Detailed Site Plan Townes at Brandywine Crossing

SUBJECT: Detailed Site Plan DSP-19016

Type 2 Tree Conservation Plan TCP2-024-2021

Townes at Brandywine Crossing

Figure 1: Site Plan

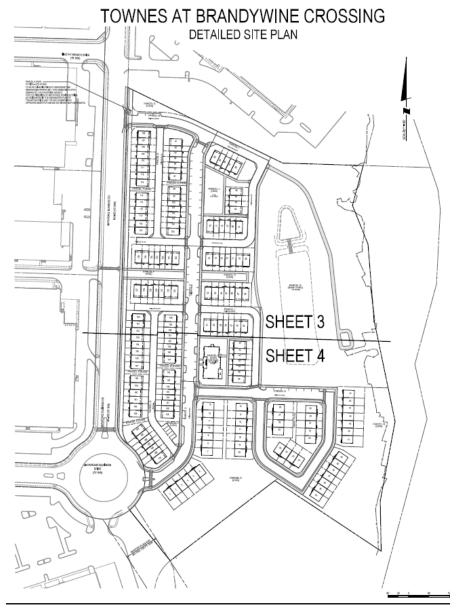
A photometric plan provided with the DSP shows adequate lighting provided for all private streets, but not for the alleys. Therefore, a condition is included herein requiring this be revised to include lighting of the alleys. Two free standing monument signs with the "Townes at Brandywine Crossing" name are shown, one adjacent to each access point to the site. The size and design of these signs is acceptable. Private on-site recreational facilities are proposed to serve the development and include an approximately 3,700-square-foot clubhouse with a fitness room and function space, a tot lot, trails, seating, and open space areas. Architectural elevations provided for the clubhouse show it will be of a modern design and include the use of high-quality materials, such as brick or stone veneer. The recreational facilities provided are appropriate for the development.

- 1. Prior to certification, the detailed site plan (DSP) shall be revised, as follows:
 - a. Provide additional landscape screening on the west side of Lot 1, to buffer it from the master planned right-of-way.

- b. Provide raised/tabletop crosswalks at the southern vehicular entrance to the site to further reduce the speed of drivers as they enter the site, as an added safety measure.

- c. Delete the R3-17/BIKE LANE signs from Matapeake Business Drive.
 - d. Standard D-3 street name sign blades that read "Timothy Branch Trail" where the Timothy Branch Trail intersects with roadways and indicate their locations on the site plans.

- e. Revise the photometric plans to provide sufficient lighting of all alleys.
 - f. Designate the high and medium visibility lots within the DSP.
 - g. Provide a development standards chart on the DSP to include regulations for building height, lot size, lot coverage, setbacks, frontage, sheds, fences, and decks.
